**File:** A083/20

**Address:** 2 Winterlude Court, Kleinburg

Minor Variance  
Application

**Purpose:** Relief from By-law 1-88, as amended, is being requested to permit reduced minimum soft landscaping to accommodate the existing Bocce Court located in the rear/exterior side yard.

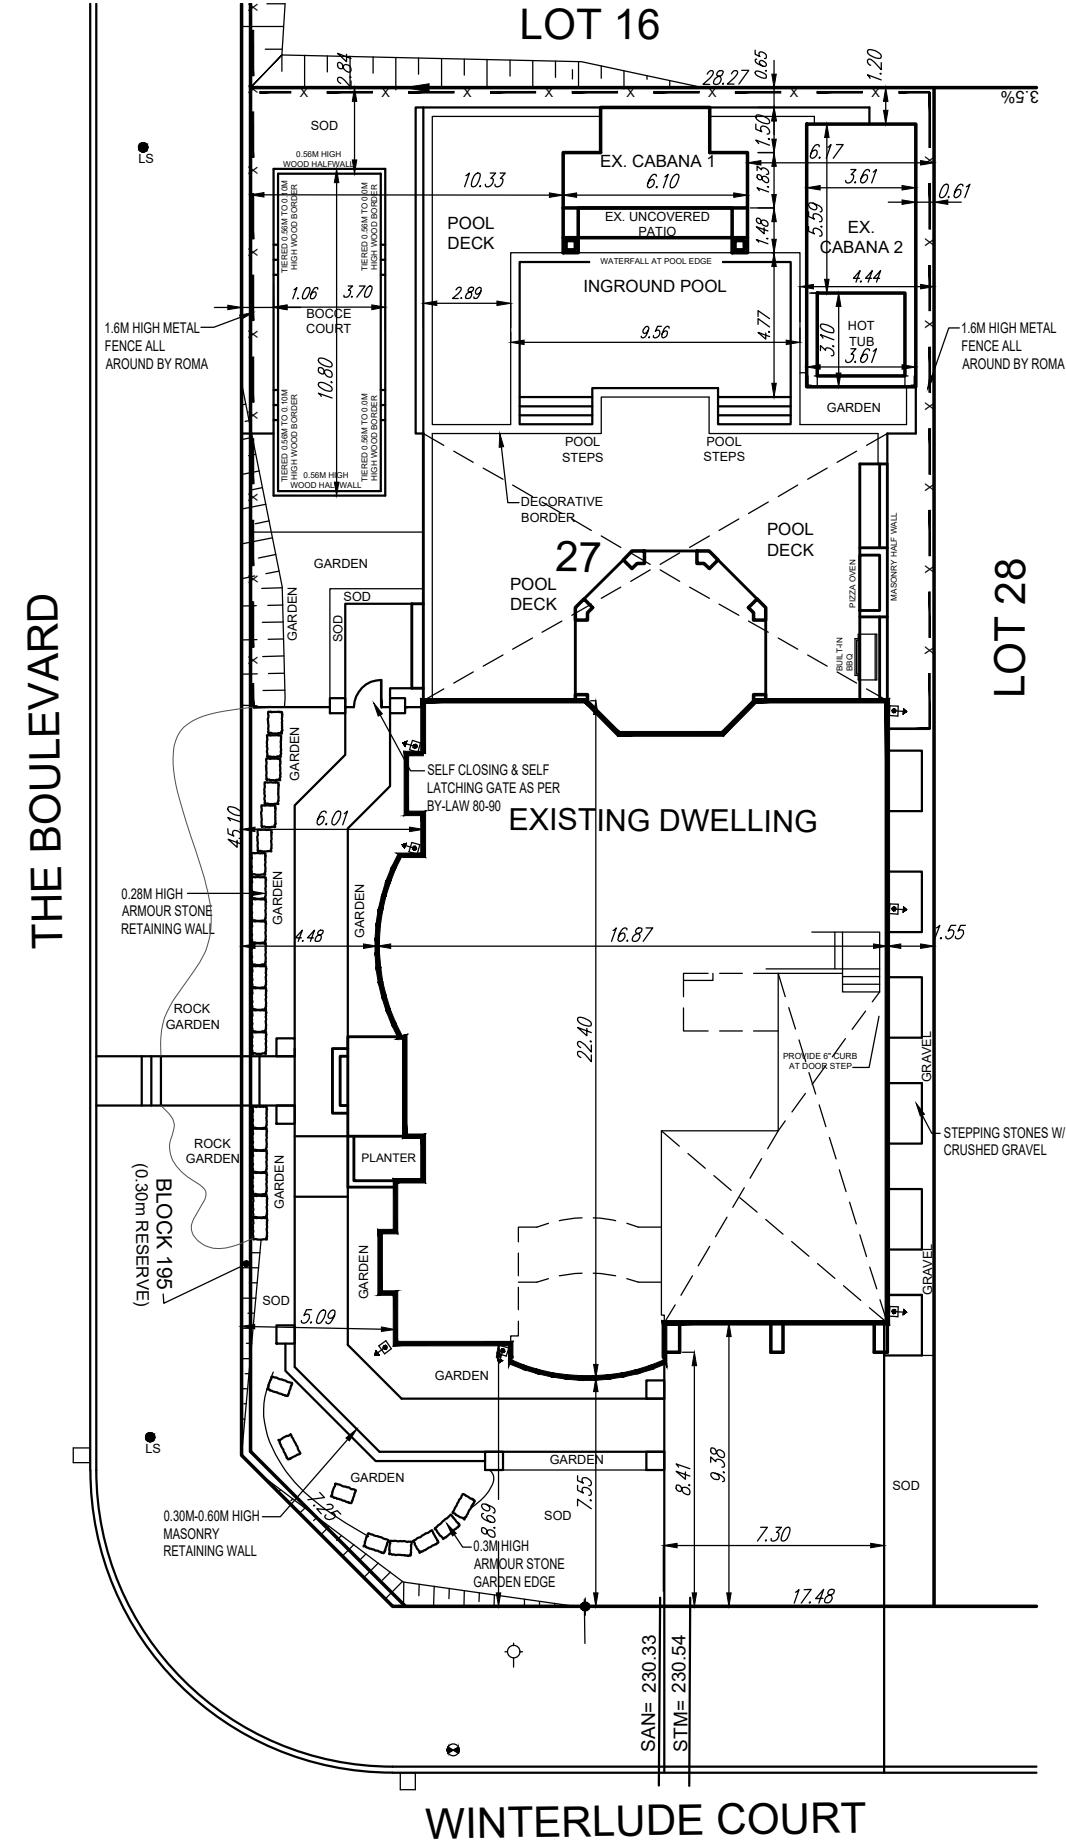
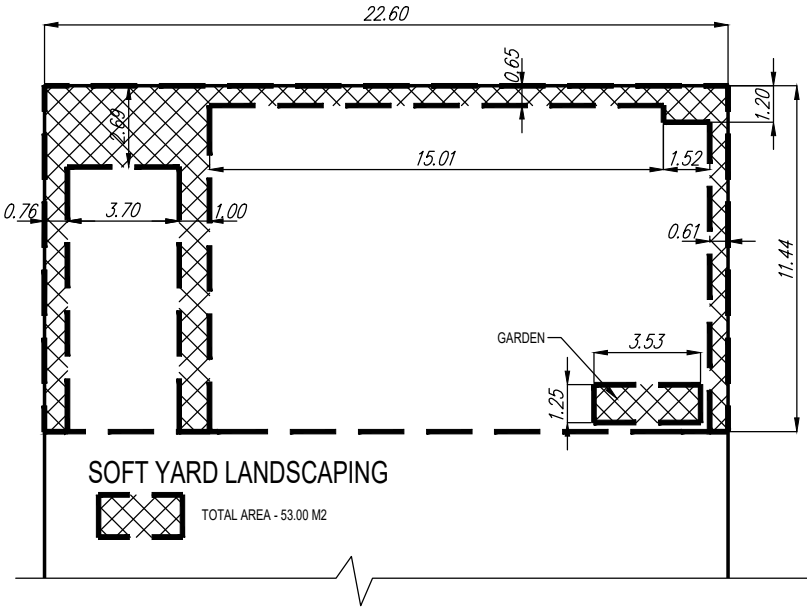
The Development Engineering Department has reviewed the minor variance for the proposed 42.9% soft landscaping within the rear yard when a total of 60% is required and has received confirmation from the applicant that the Bocce Court within the rear yard is pervious and allows for drainage. Based on the review of the materials used for the Bocce Court, Development Engineering Department has confirmed that the court is permeable and allows for drainage and will include it as a soft landscaping calculation.

In addition, the applicant had submitted a Stormwater Drainage Assessment which clearly identifies that the Bocce Court has provided a reduced Storm Discharge Rate when compared to sod. In the event, that the Bocce Court cannot be deemed soft landscaping it has been proven to have reduce stormwater surface discharge which eliminates the concerns of additional stormwater entering into the storm system. With this information, Development Engineering Department has no concerns or objections to minor variance application A083/20.

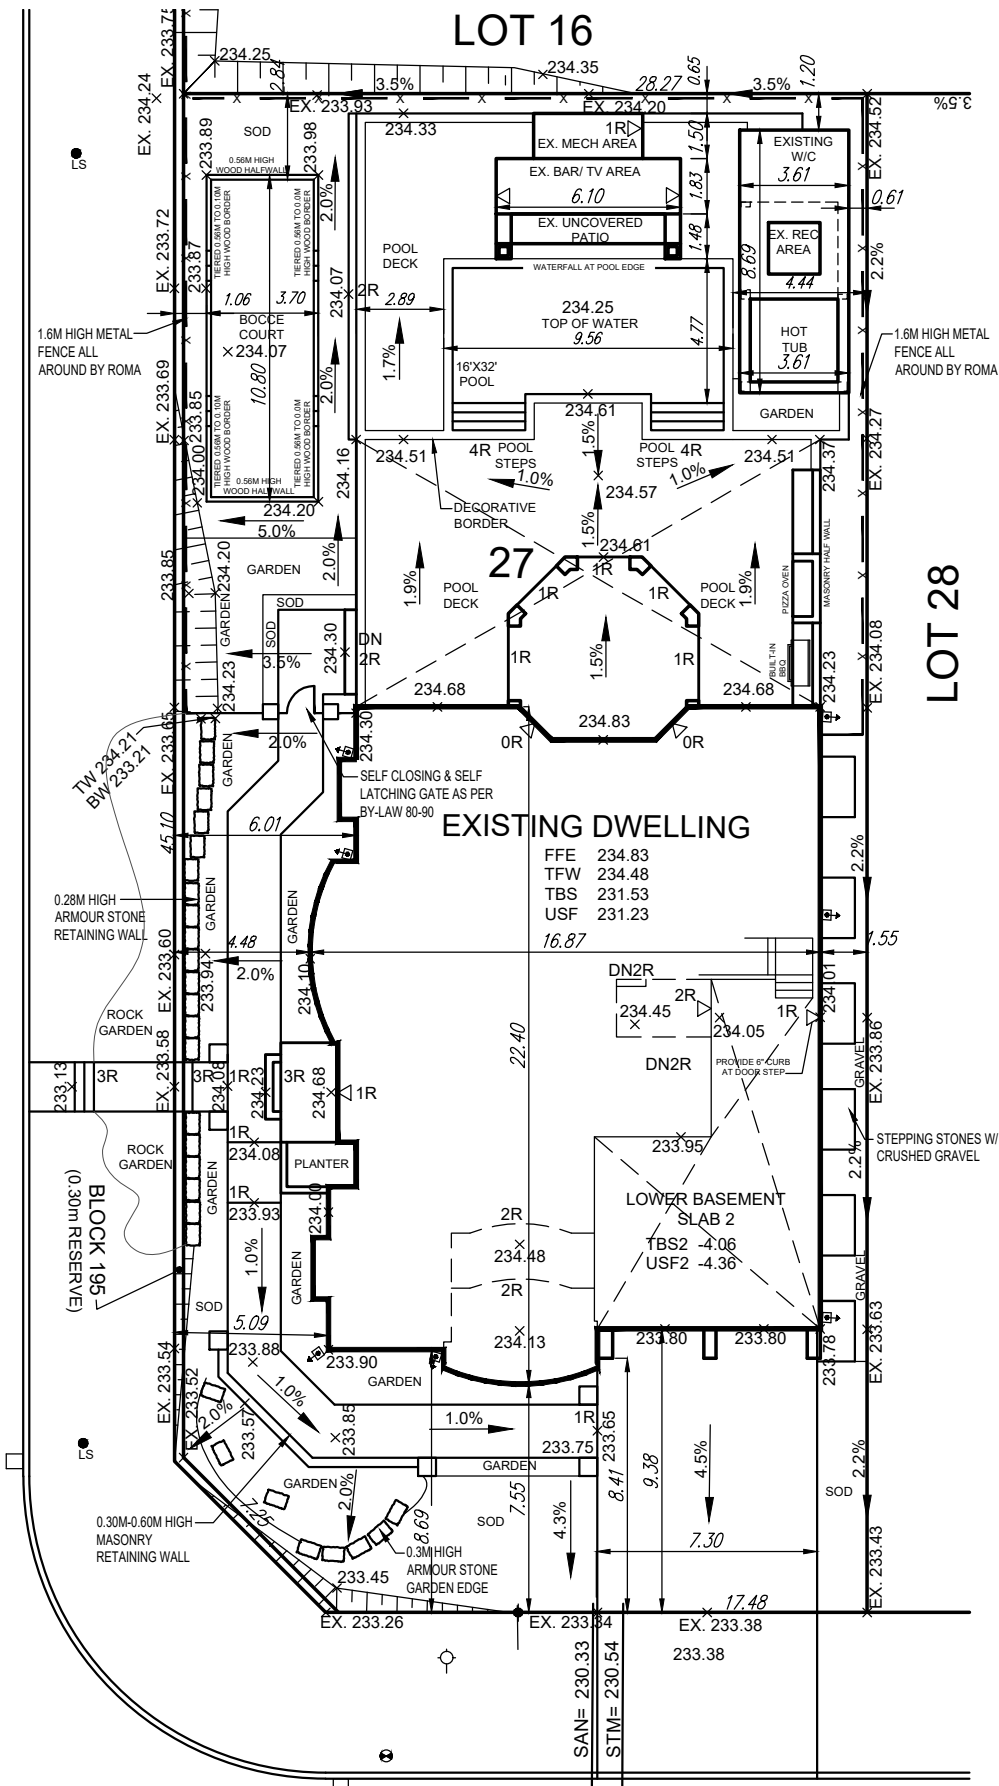
A grading plan for 2 Winterlude Court was designed by Ian Robertson Design and reviewed/ approved by Condeland Engineering on July 22, 2019. The City of Vaughan Zoning department interpreted the bocce court to be part of the hardscape calculations because the materials used do not fall under the definition of 'soft' landscaping as set out in the zoning by-law 1-88. The City of Vaughan Engineering department determined that the materials used in the construction of the bocce are indeed permeable and should not be included as part of the hardscape calculations.

The minimum landscape requirement for a rear yard in excess of 135m<sup>2</sup> is 60%. The soft landscaping calculation as determined by the zoning department is 42.9%. This is excluding the bocce court. The soft landscaping calculation as determined by the Engineering department is 69% as they are including the bocce court in this calculation.

We can confirm that the landscaping at the above-noted address has been completed as per the attached drawings and conforms with all applicable standards.
